Agenda
Village of Arlington Heights
Design Commission
Community Room, 3rd Floor

Arlington Heights Village Hall
33 S. Arlington Heights Road
Arlington Heights, IL 60005
April 28, 2015
6:30 PM

MINUTES OF
THE VILLAGE OF ARLINGTON HEIGHTS
DESIGN COMMISSION MEETING
HELD AT THE ARLINGTON HEIGHTS MUNICIPAL BUILDING
33 S. ARLINGTON HEIGHTS RD.
APRIL 14, 2015

Revised Sign Design

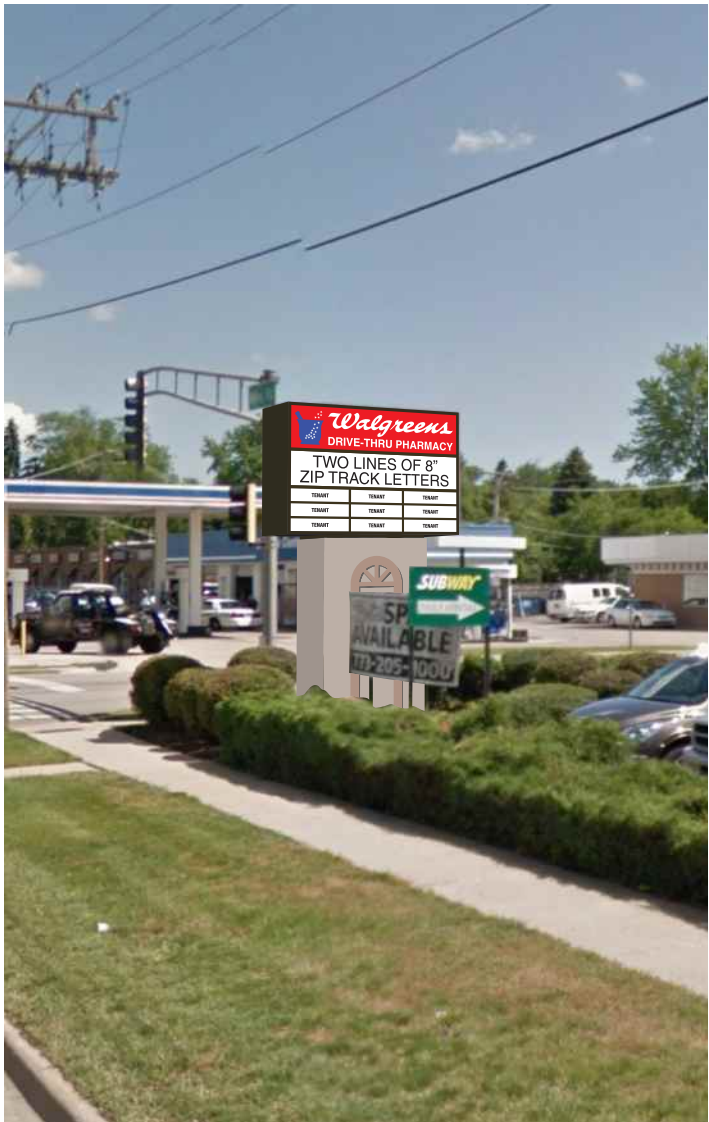
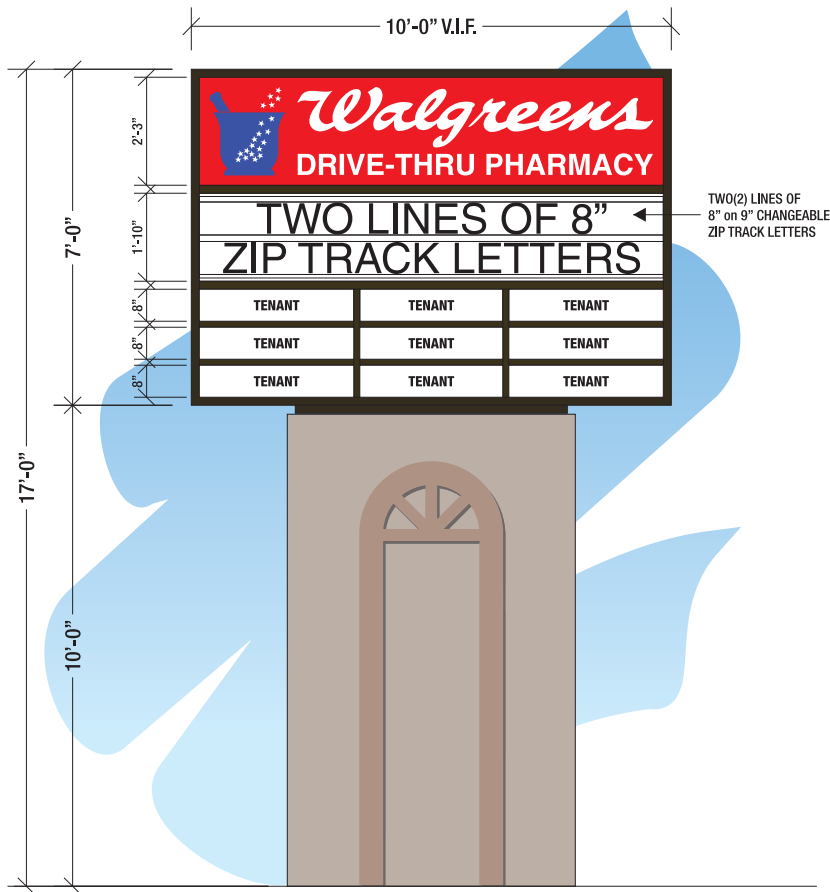
In response to the feedback from the Design Commission, the petitioner provided a design for modifications to the existing Walgreens sign to incorporate tenant panels below the sign, but reported that Walgreens did not approve their request.

To assist with obtaining Walgreens' approval, Staff prepared a design for a new, code-compliant, monument style, multi-tenant, Walgreens sign to replace the existing, weathered, pole mounted Walgreens sign at the corner of the site. Staff reviewed the sign concept with Walgreens and explained that a new monument style sign and new corner landscaping would be beneficial to Walgreens and all of the retail tenants by enhancing the overall image of the retail center, as well as by bringing the signage closer to eye level for vehicular and pedestrian traffic. Additionally, a new multi-tenant sign can further benefit Walgreens and all of the tenants by creating a synergy of attracting customers to shop at this location. On December 5, 2014, Staff obtained Walgreens approval of the proposed multi-tenant sign design. However, Walgreens was not willing to contribute to the cost for the new sign.

PROPOSED MONUMENT SIGN

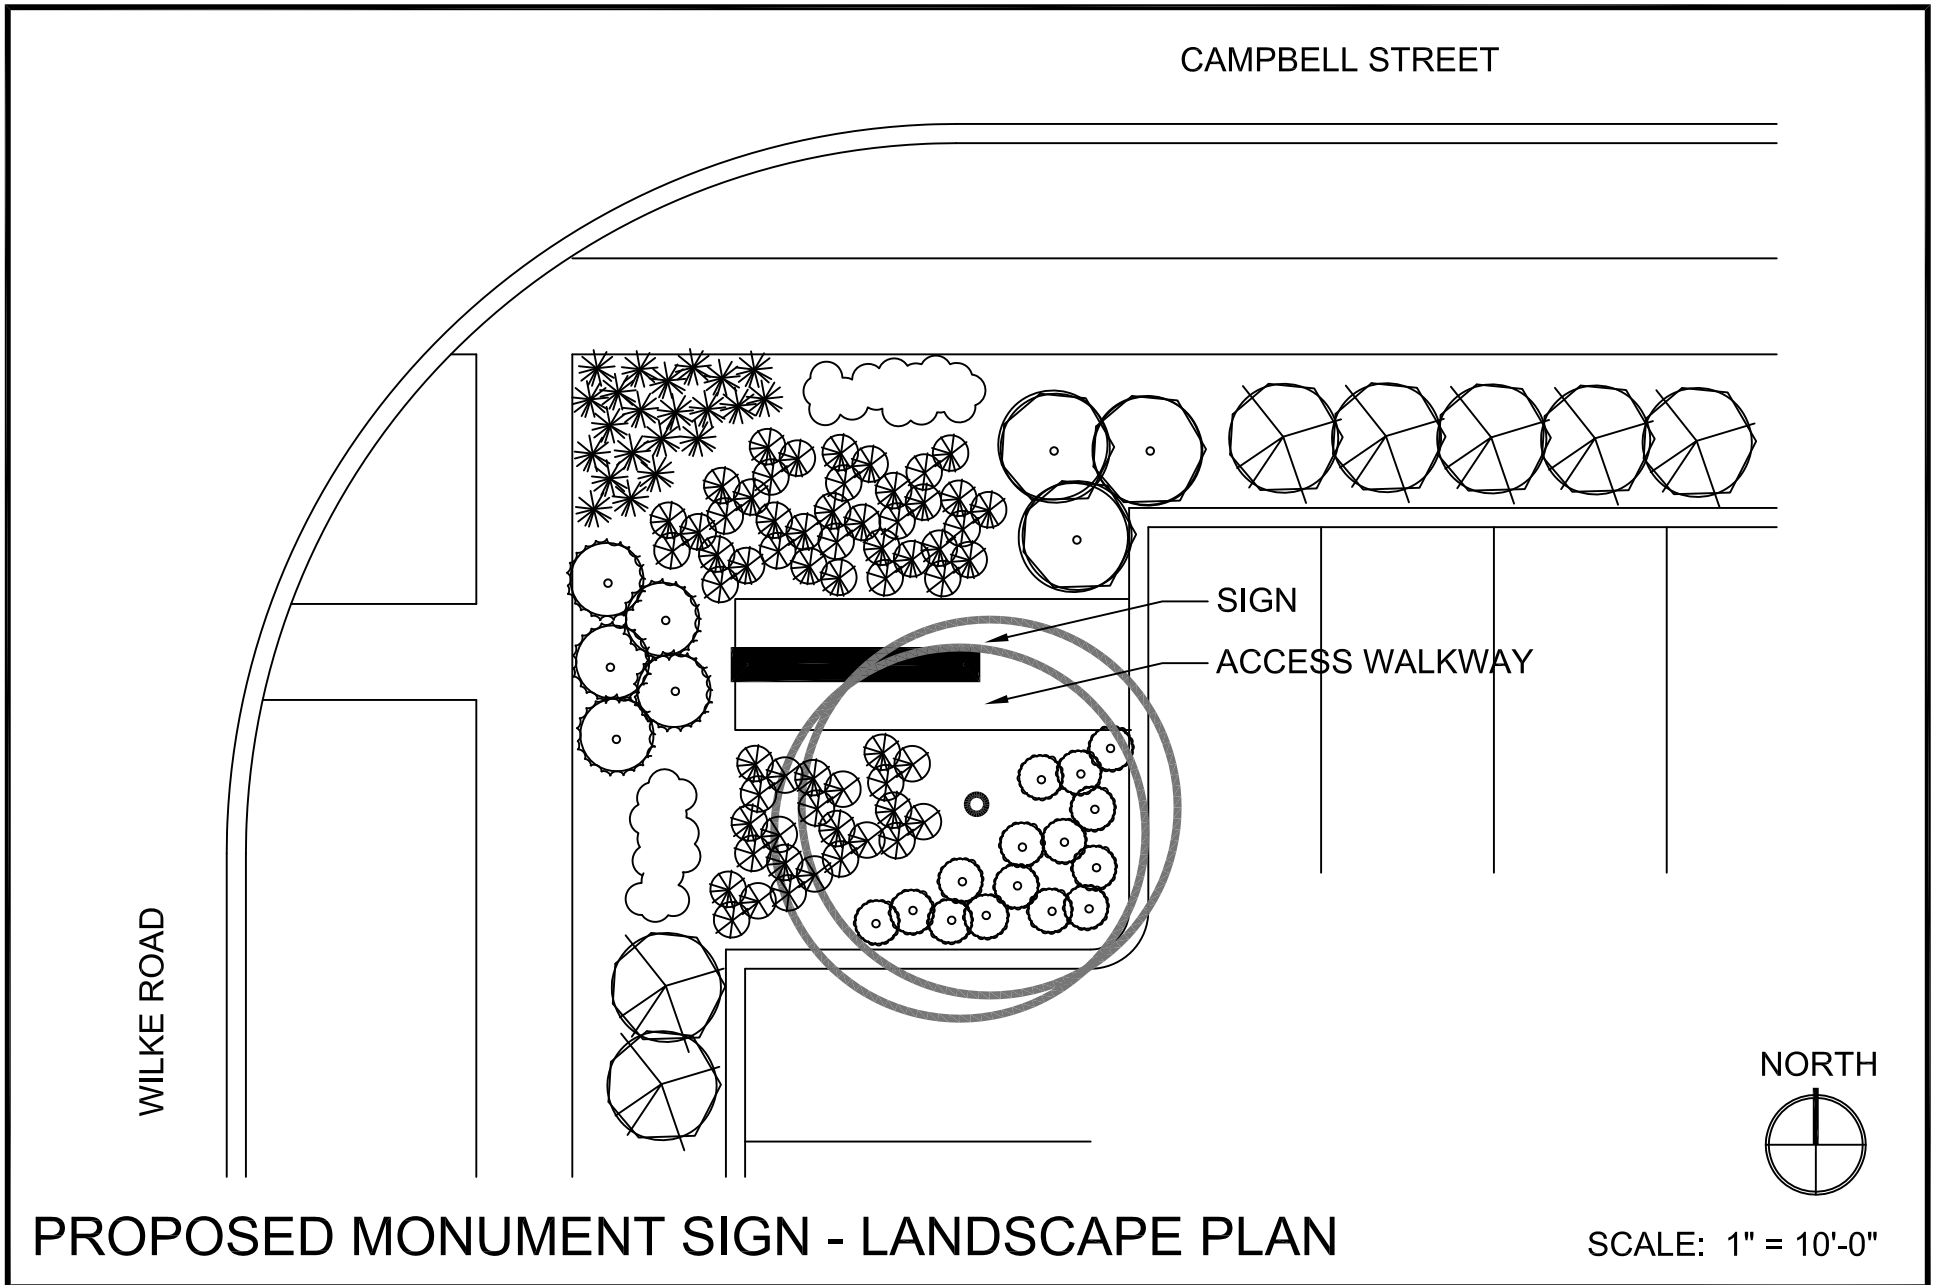
Staff maintains the position that the existing sign on Campbell Street is non-compliant, it is out of character with the residential neighborhood, and it should be removed. A new, code-compliant, multi-tenant sign at the corner of the site is the most appropriate ground sign solution for this site. It will provide the best visibility, and having only one sign is consistent with other retail centers of this size in Arlington Heights. If the owner's budget does not allow for replacement the corner ground sign at this time, then it is recommended that they establish a cost sharing program with all of the tenants to raise the needed funds over time, and install the new sign as soon as it is financially feasible.

1. A requirement that the existing sign structure along Campbell Street be removed.
2. A recommendation that the Petitioner replace the existing Walgreens sign at the corner of the site with a new, code compliant, multi-tenant, monument style ground sign similar to the conceptual design as prepared by the Planning and Community Development Department dated 11/26/14.
